A receiver-agnostic approach to ETCC

Supporting contribution for Draft 2.2 comment #251

IEEE 802.3 November 2025 plenary

Figure 185A-2—Calibrated coherent detector front-end

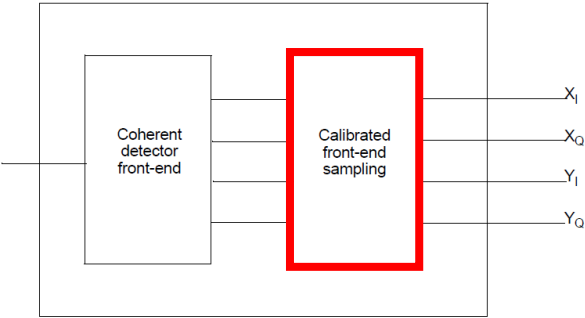
Editorial changes: Pg 943 - Calibrated front-end sampling

The calibrated front-end sampling function performs the analog-to-digital conversion of the four electrical signals obtained from the coherent detector front-end and compensates for the front-end imperfections listed in Table 185A-2.

The calibrated coherent detector front-end shall exhibit a flat frequency response, with magnitude and phase variations within the limits specified in Table 185A-2. Compliance with these limits may be achieved through the implementation of a digital equalizer applied prior to the ETCC noise-loading and calculation process.

The receiver noise impairing the digitized signal shall exhibit a flat power spectral density across the occupied signal bandwidth, with variations within the limits specified in Table 185A-2. If the intrinsic receiver noise does not meet this requirement, additive colored noise shall be synthesized and applied to the sampled waveform such that the aggregate receiver noise presented to the ETCC processing is effectively white. The calibrated receiver-noise power spectral density shall be known and shall be used in the ETCC computation as specified in 185A.2.5. The signal-to-receiver-noise ratio of the sampled waveform after noise whitening shall comply with the minimum value defined in Table 185A-2.

Table 185-15 & Table 187-13 —Coherent front-end frequency response and noise post calibration residuals

Description	Value	Unit
Frequency response magnitude variation (max)	1	dB
Frequency response phase variation (max)	0.3	rad
White noise power spectral density variation (max)	0.1	dB
Signal-to-Receiver-Noise Ratio (min)	20	dB
